Designation: C 1405 – 01**b**₂

Standard Specification for Glazed Brick (Single Fired, ~~Solid~~ Brick Units)¹

FIG. 1 Types of Hollow Glazed Brick Units

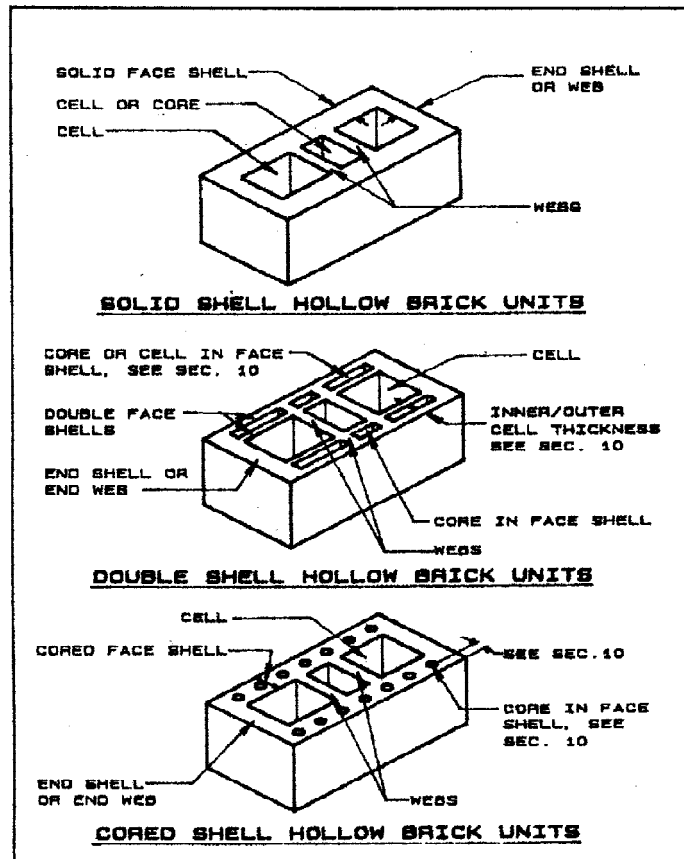
4.4.3 *Division H60V*—Brick with void area greater than 40 % but less than or equal to 60 % of its gross cross sectional area, measured in any plane parallel to the surface containing the cores, cells, or deep frogs. The shell thicknesses shall comply with the requirements in Table 1. See Fig. 1.

(1) ~~The standard was modified to include hollow brick. The title was changed to include hollow brick. Section 1.5 was modified to add Divisions. Section 4.4 was added to identify Divisions. Section 10 was modified for hollow spaces. Figures 1 and 4.1.2 2 and Table 1 were revised~~ added to refer to unit dimensions rather than mortar joint dimensions; clarify requirements in Section 10.

FIG. 2 Unexposed Face, Distance to Voids

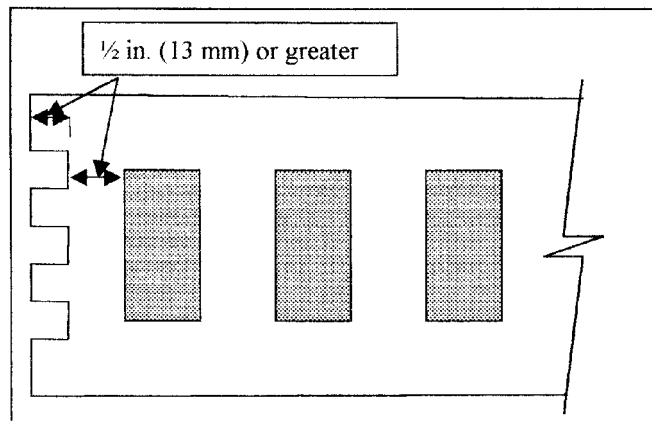
10.4 *Unexposed Face*—The distance of hollow spaces to grooves recessed 1/2 in. (13 mm) or greater, shall be not less than 1/2 in. (13 mm). See Fig. 2.
